Proposed Mining and Reclamation Plan, Antelope Mine, Converse County, Wyoming

Final
Environmental Impact Statement
OSM-EIS-5

February 1982

Proposed action: Approval of the mining and reclamation plan submitted by Antelope Coal Company (NERCO) for the Antelope mine.

Figure IV-5.--Public access routes.

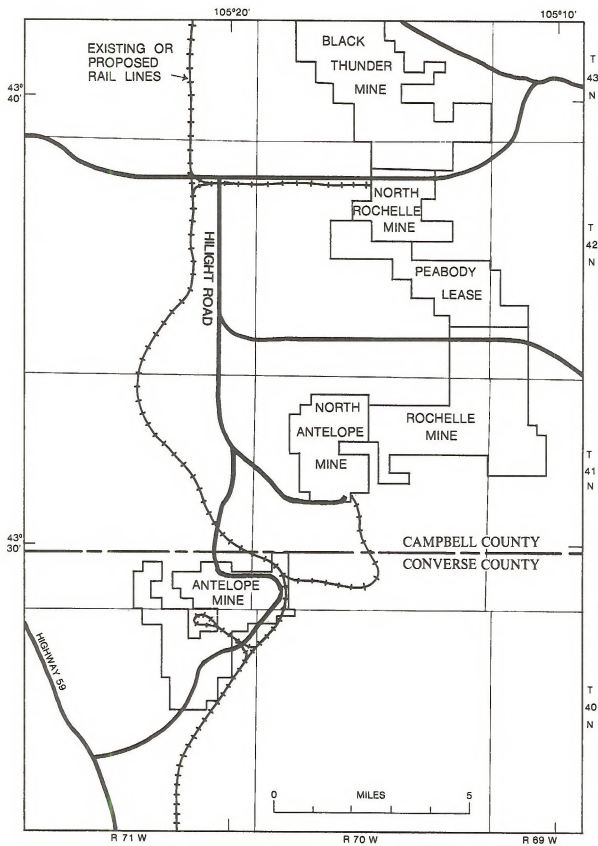
- On pages IV-26 and IV-27 of the draft EIS there is a discussion of potential access routes to and through the minesite; figure IV-5 of the draft EIS shows a "road corridor" which would accommodate these potential routes. Since publication of the draft EIS, NERCO has met with the Forest Service and with representatives of Converse County to finalize the location of the access route. The selected location for the new Verse-Hilgert Road is shown on the revised figure IV-5, printed in chapter II of this volume.

Because of the scale and the amount of other data presented, the Verse-Hilgert Road is not shown in figure I-1. On figure IV-5, it is the road running through the Antelope mine site and should have been labelled.

20

Figure A-2.--Acres disturbed and acres reclaimed during mining.

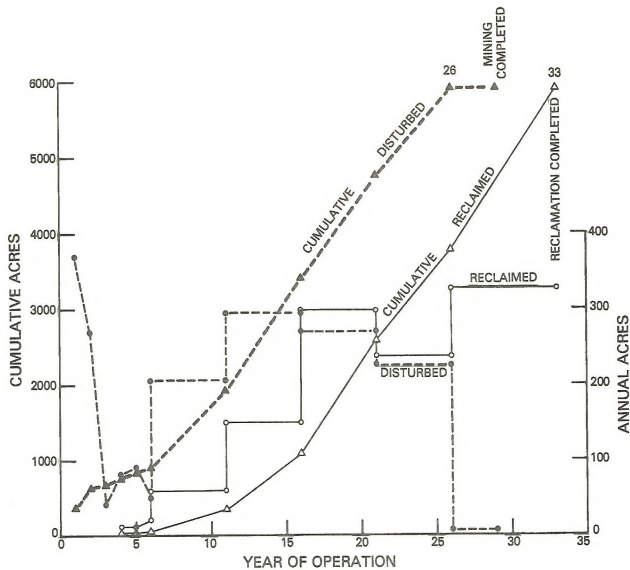
The following figures and tables either supplement or replace figures and tables in the draft EIS. Table III-3 is a new table and should follow page III-6; figures IV-5 and A-2, and tables IV-3, IV-4, and A-3, replace the corresponding figures and tables on pages IV-30, A-4, IV-21, IV-24, and A-11, respectively, of the draft EIS.
